UNITED STATES
NUCLEAR REGULATORY COMMISSION
REGION II
SAM NUNN ATLANTA FEDERAL CENTER
61 FORSYTH STREET SW SUITE 23T85
ATLANTA, GEORGIA 30303-8931

SUBJECT: FINAL SIGNIFICANCE DETERMINATION FOR A GREEN FINDING (NRC INSPECTION REPORT 05000395/2005007, VIRGIL C. SUMMER NUCLEAR STATION)

NRC Regulatory Conference VC Summer Nuclear Station

Drawing of 8 inch schedule 40 pipe with $\frac{1}{2}$ inch thick tubercles on top and $\frac{1}{4}$ inch thick tubercles on the bottom of the pipe

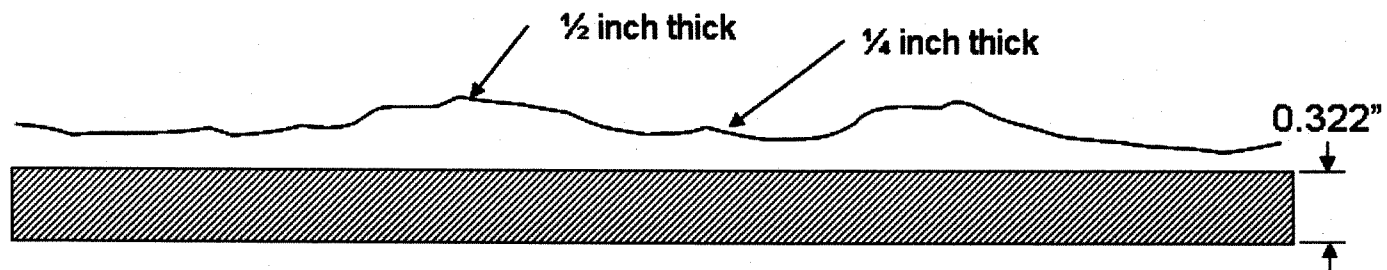
Limited Tubercle Buildup in SW Cross-Connect to EFW

- Tubercle layer is $\frac{1}{4}$ to $\frac{1}{2}$ inch thick
- Diameters generally between $\frac{1}{2}$ and $\frac{3}{4}$ inches.

Composition of Tubercle

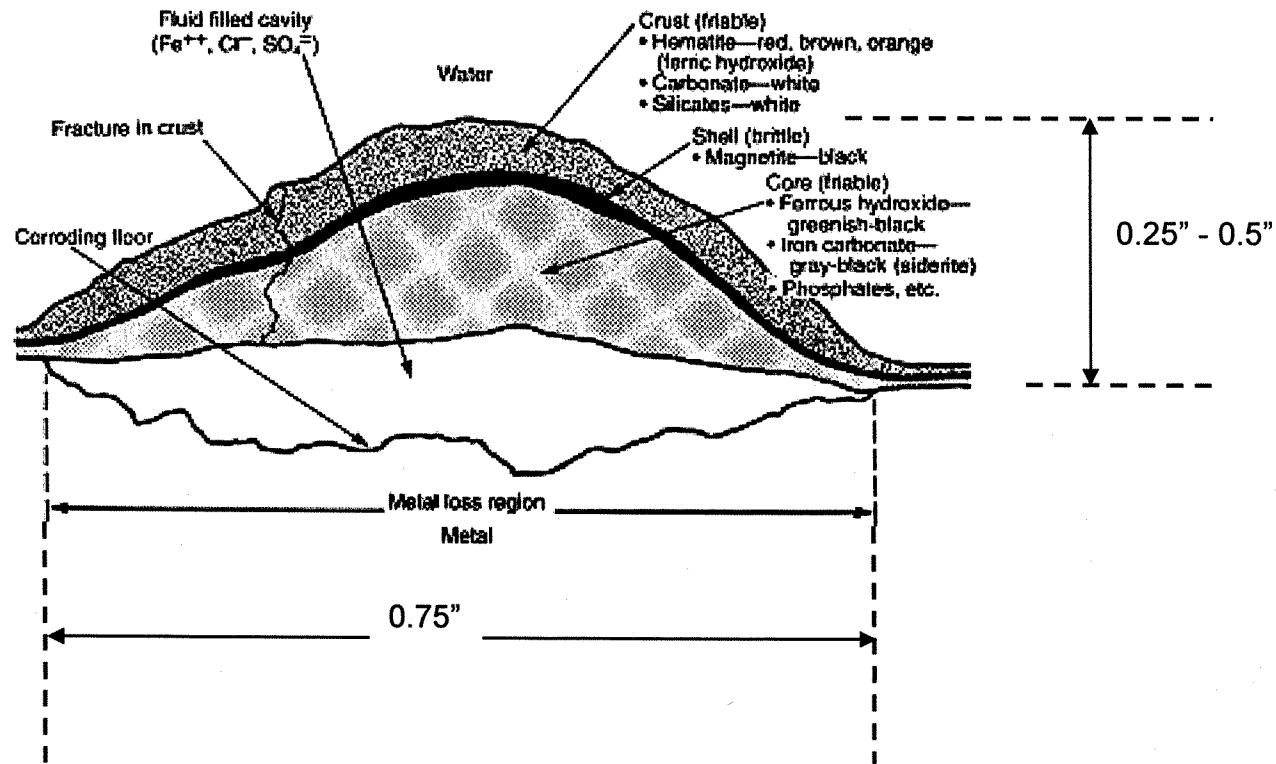
Tubercles have a friable (easily crumbled or pulverized), hematite outer crust; a brittle magnetite inner shell surrounding friable core material.

This composition differs significantly from sample material removed from the SW screen structure.

NRC Assumption

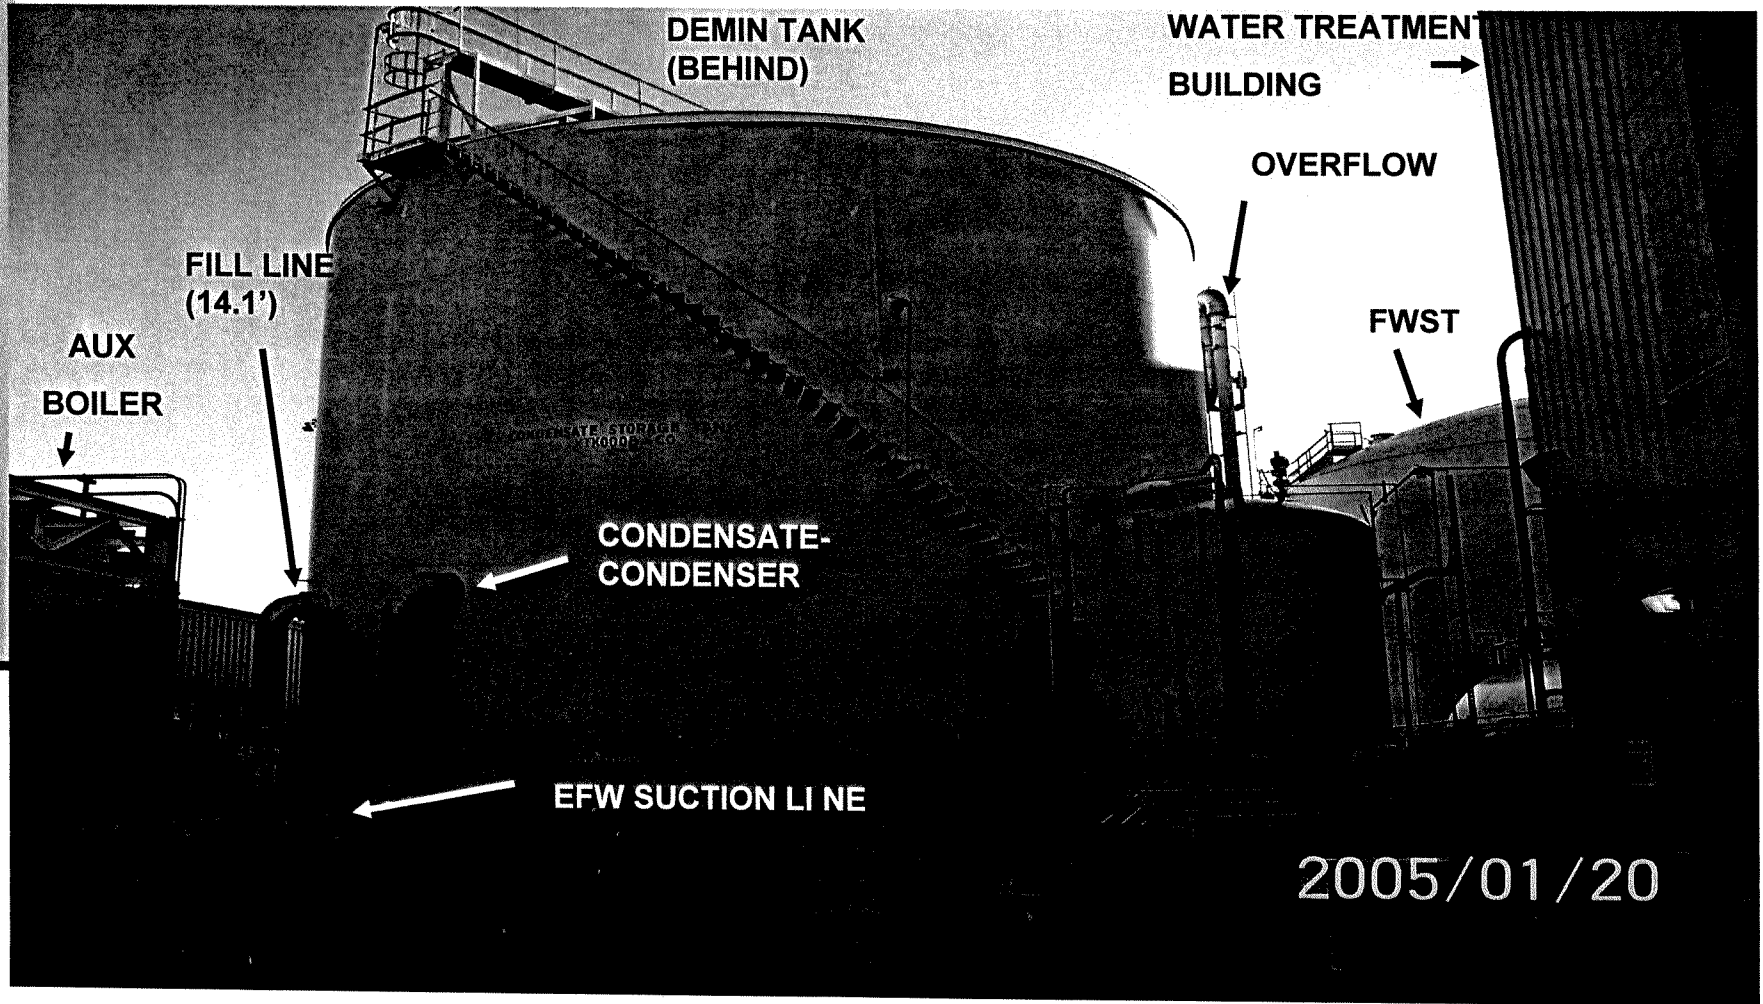
- The CST function is lost at the medium wind speed/intensity of an F2 tornado

CST Layout Drawing

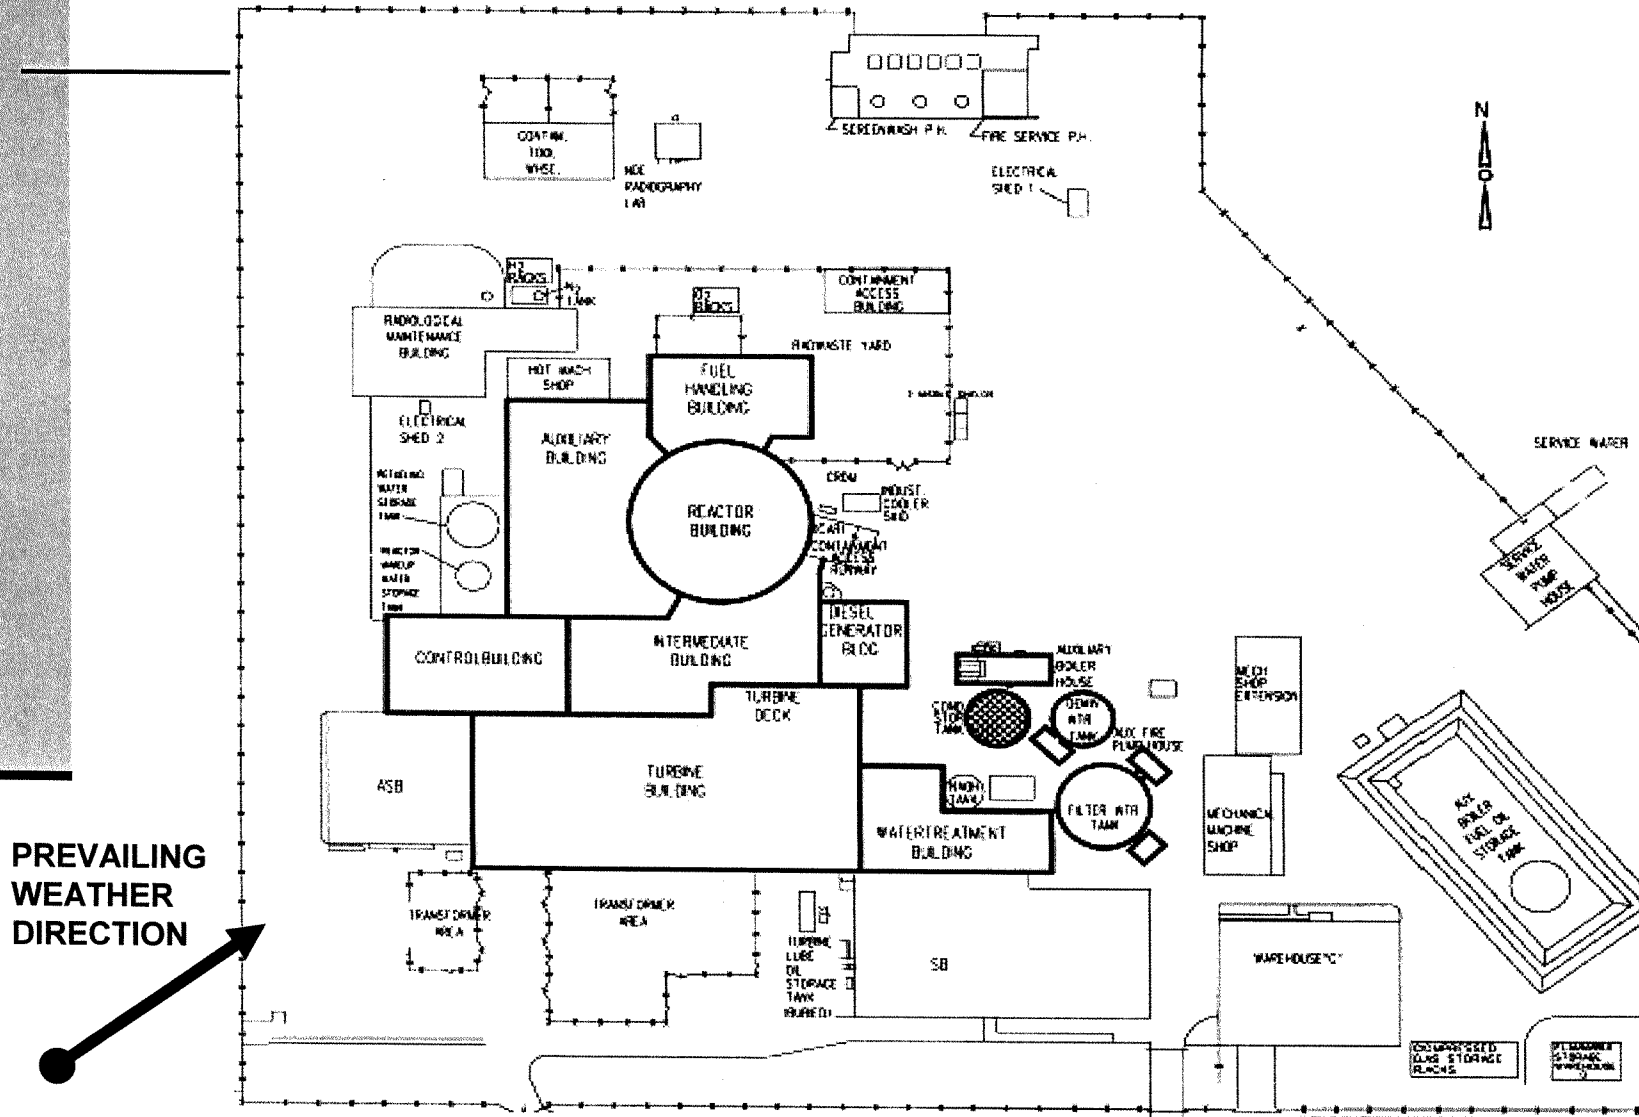
CST Design Evaluation

Seismic Design – Tank Shell Stress	19.6 psi (Top) 41.1 psi (Bottom)
F2 (157 mph) Max. Wind Load	0.44 psi
F2 (ΔP) Load	0.52 psi

Conclusion: CST Seismic Design Significantly Exceeds F2 Tornado Wind Loads

CST/Piping Failure Scenario

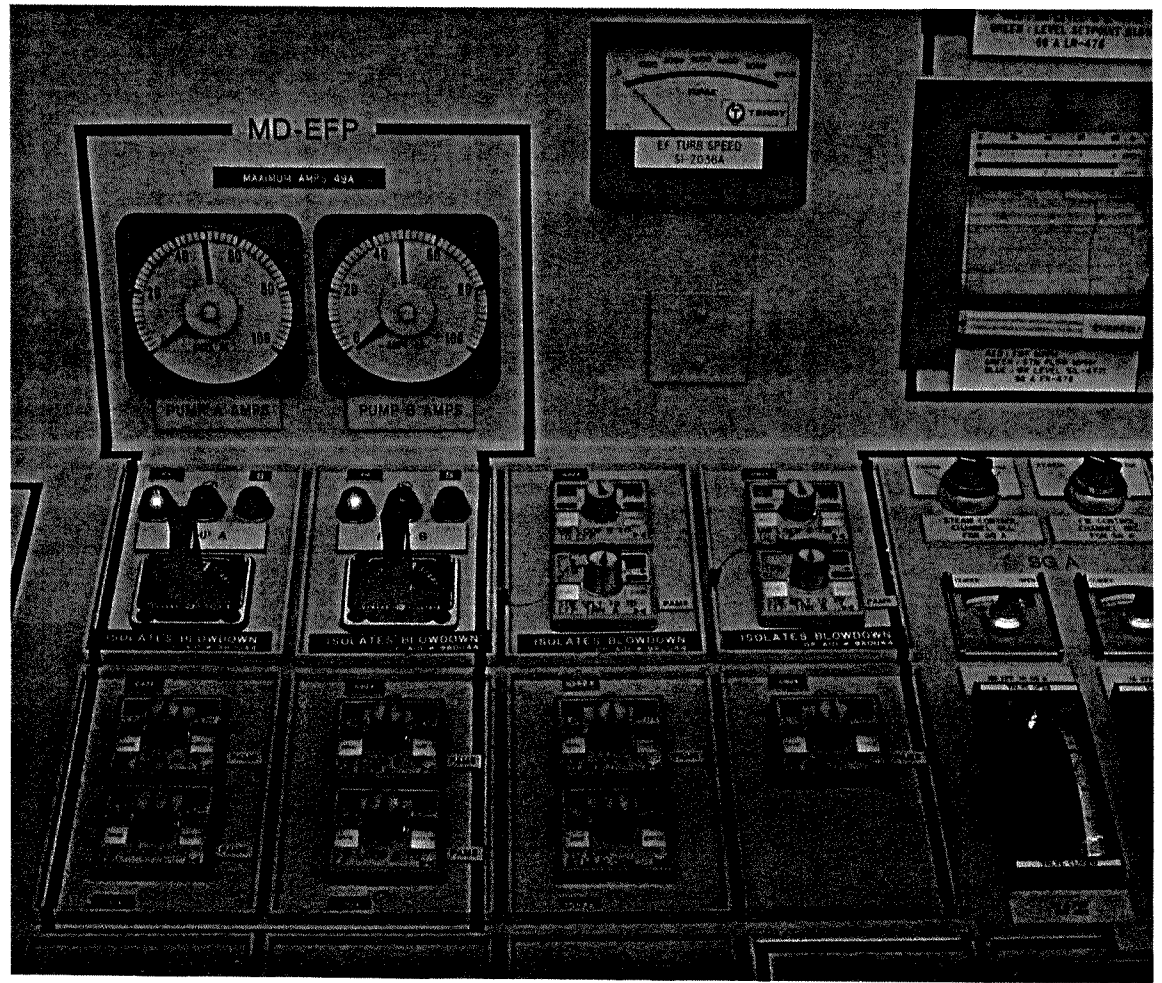
- Failure of CST as suction source for EFW system will cause a Rx trip during ensuing shutdown (Probability = 100%)
